SERVICE BULLETIN

AT05-004

2004 – 2005 ARMADA AND TITAN; ATF LEAKING FROM AIR COOLER LINE

APPLIED VEHICLES: 2004 – 2005 Titan (A60)
2004 – 2005 Armada (TA60)

Figure 1

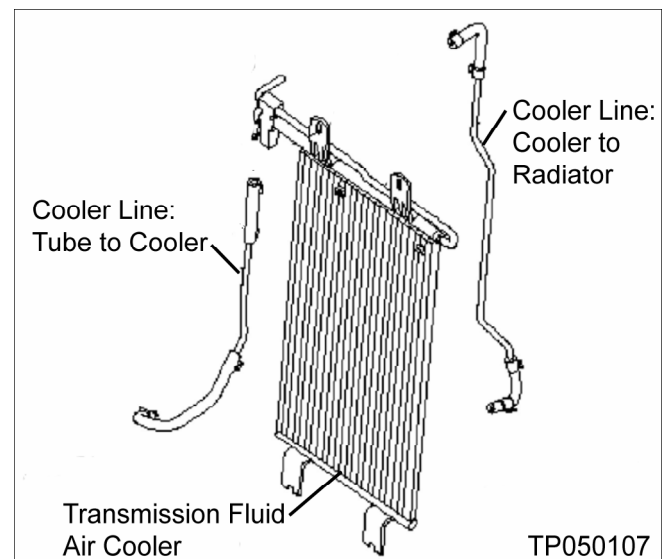
ATF is leaking from a transmission air cooler line:

- The line from tube to air cooler,
- Or the line from air cooler to radiator,

Replace the leaking cooler line.

- Make sure to replace the hose clamps that come installed on the cooler line with the new hose clamps listed in the Parts Information.
- Make sure to follow the instructions under “Additional Procedure Information” on page 3.

NOTE: New A/T cooler lines include metal tube, rubber hoses, and hose clamps.
